From: John.Hoban@rbkc.gov.uk [mailto:John.Hoban@rbkc.gov.uk]
Sent: 31 December 2013 11:57
To: Bruce Sounes
Cc: Paul.Hanson@rbkc.gov.uk
Subject: Grenfell Tower, Grenfell Road, Refurbishment - Fire Strategy P2

The Building Regulations 2010 [as amended] Grenfell Tower, Grenfell Road. London. W11.

From: d.campbell@maxfordham.com [mailto:d.campbell@maxfordham.com] Sent: 07 November 2013 15:41 To: Hanson, Paul: PC-BlgCtrl Cc: <u>"M.Smith@maxfordham.com"@maxfordham.com; Terry.Ashton@Exova.com;</u> Grenfell; Bruce Sounes Subject: Grenfell Tower - Smoke exhaust LFB submission.

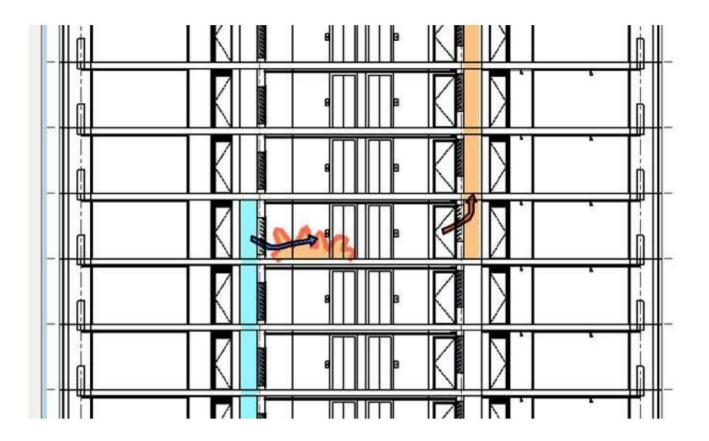
2. Some diagrams would be useful. I have attached our schematic drawing and Studio E have provided the visual representation below.
